REBID - City of San Juan Police Building Expansion

Addendum NO. 01

CSP# 25-008-05-01

Project No. 24002

PROJECT No.: 24128.00
ISSUE DATE: 04/01/25
DRAWN BY: CP
CHECKED BY:
Sheet Name
PAVING AND DRAINAGE PLAN

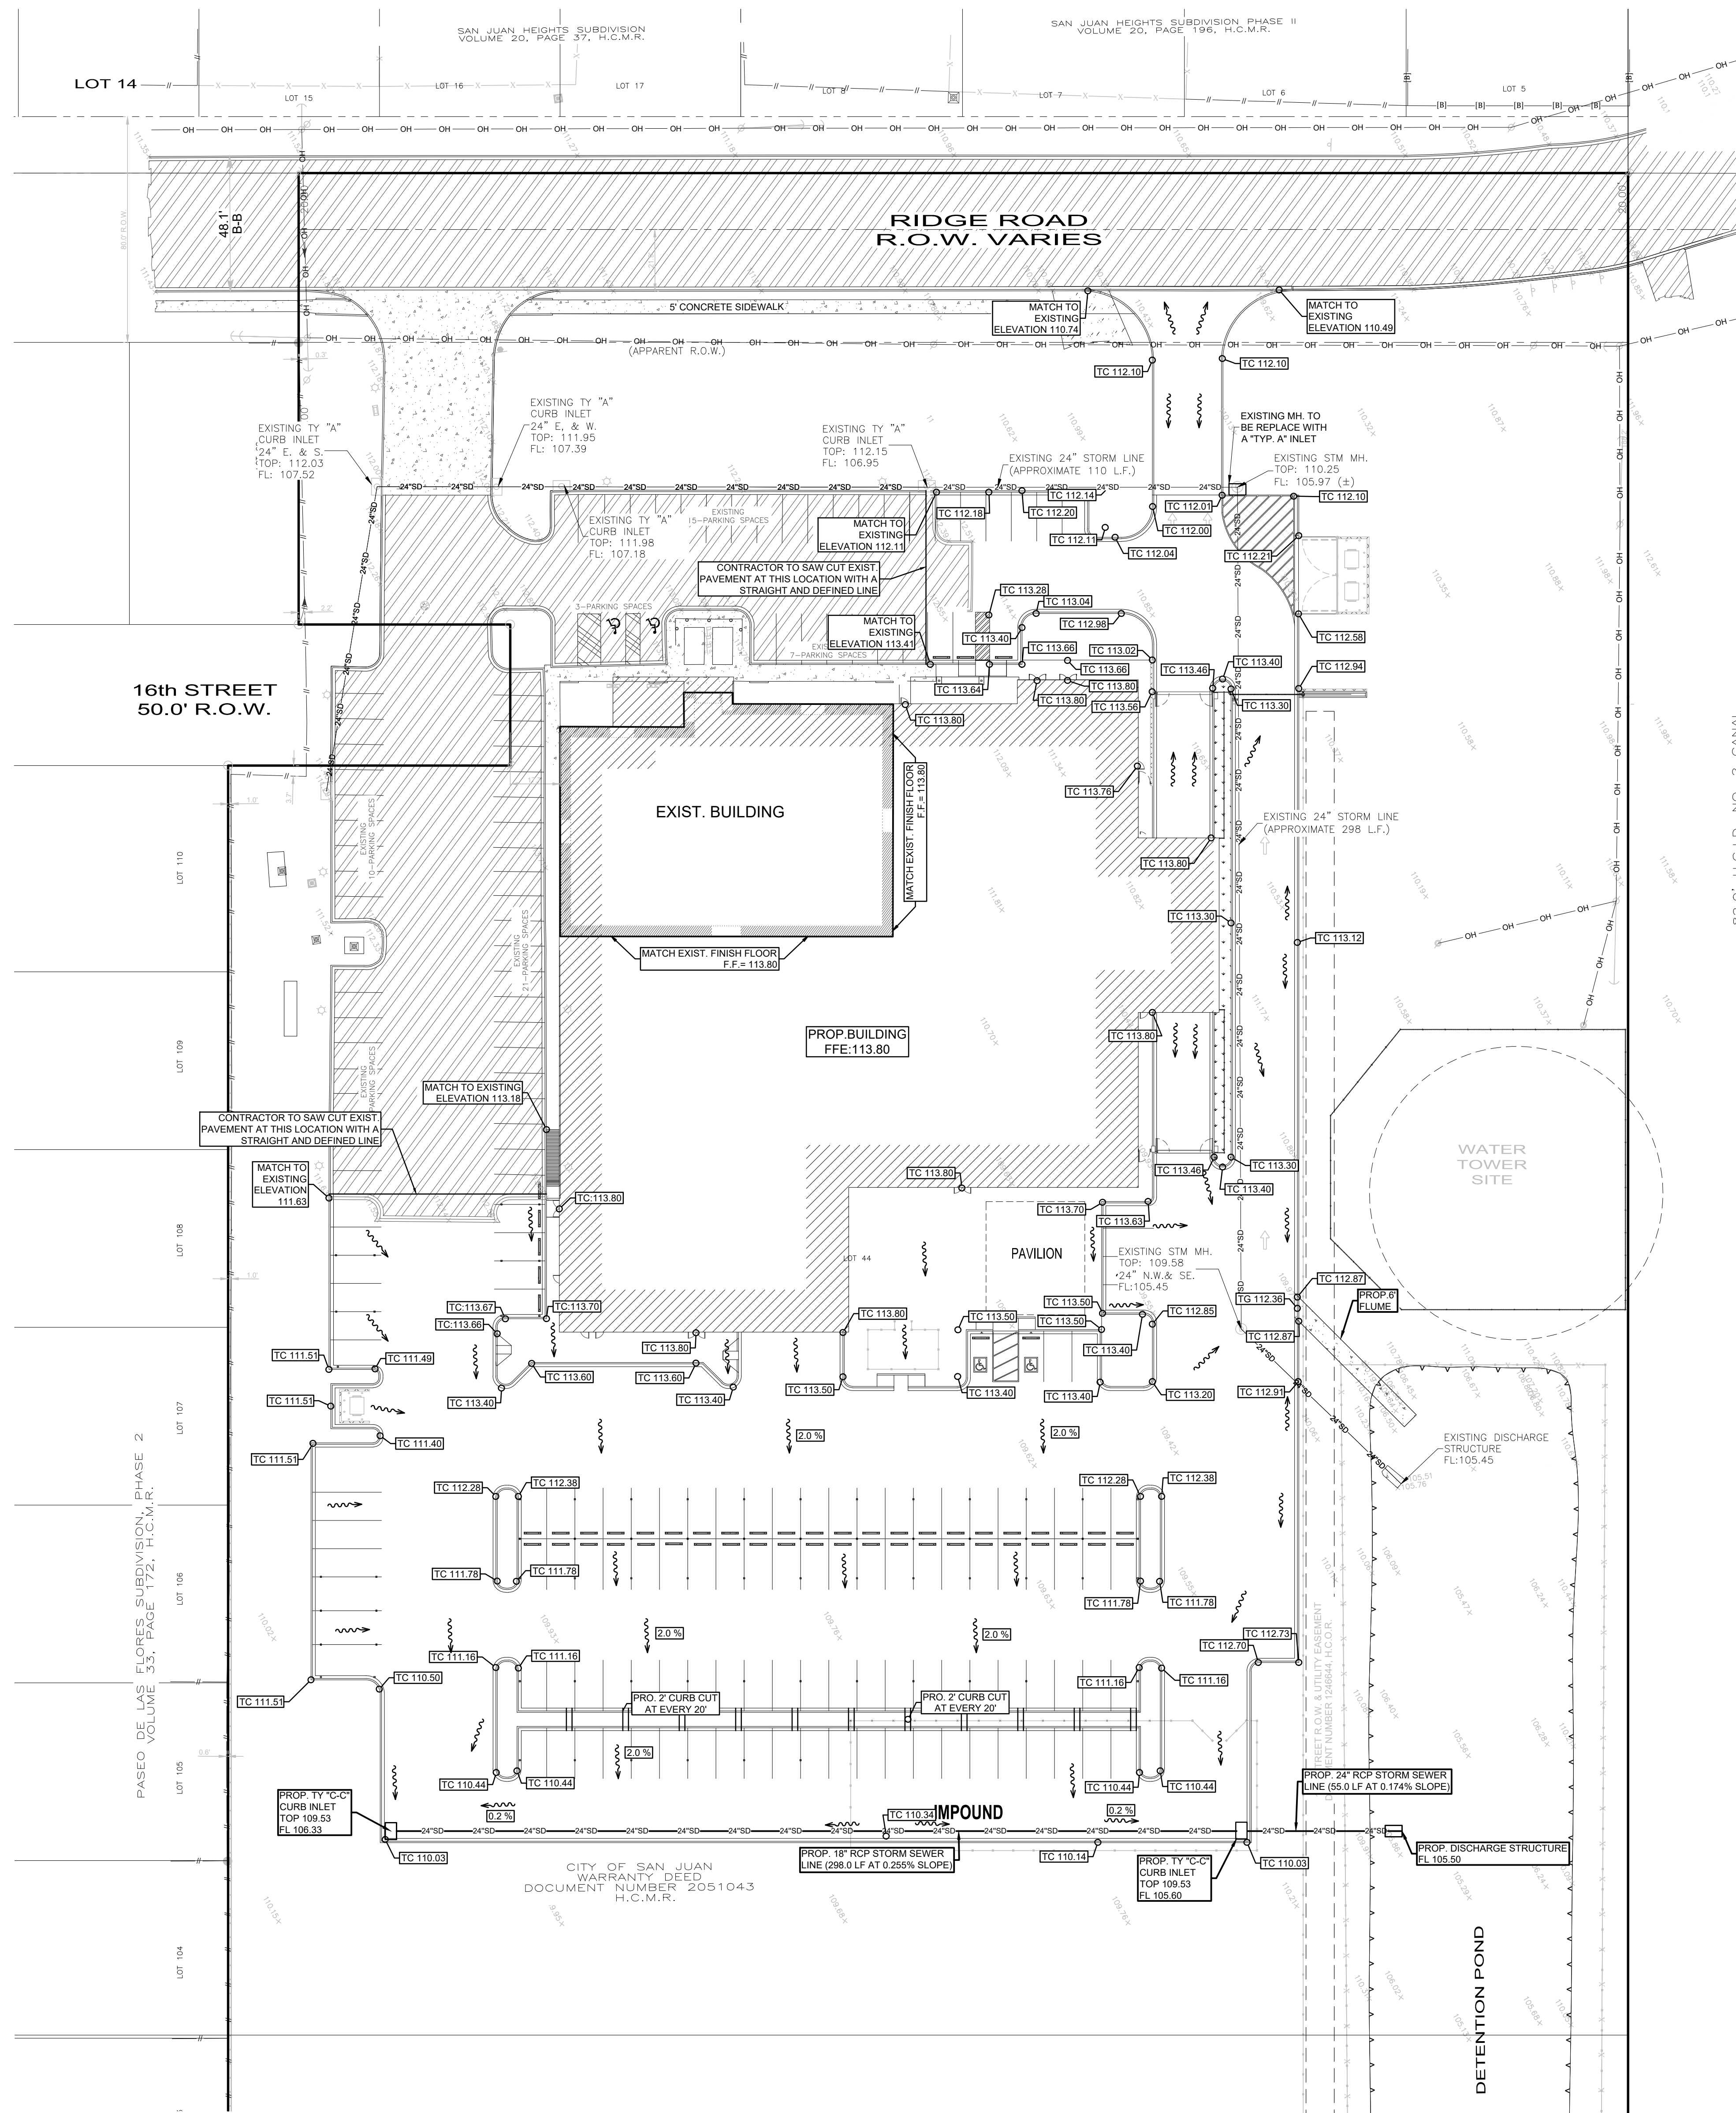
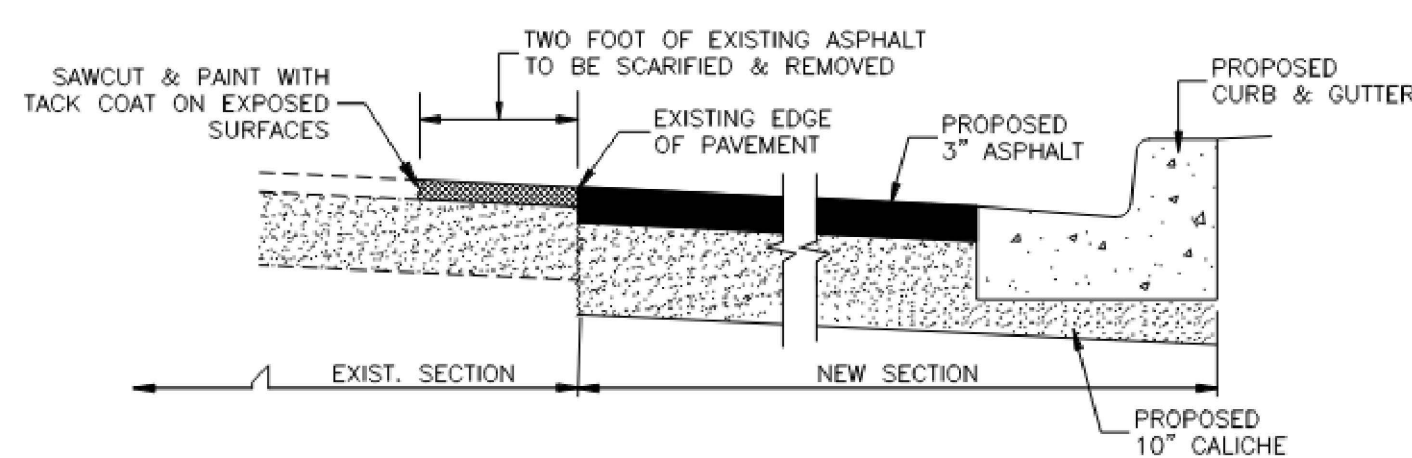
1. Replace C500 with revised Sheet C500 (refer to attached).
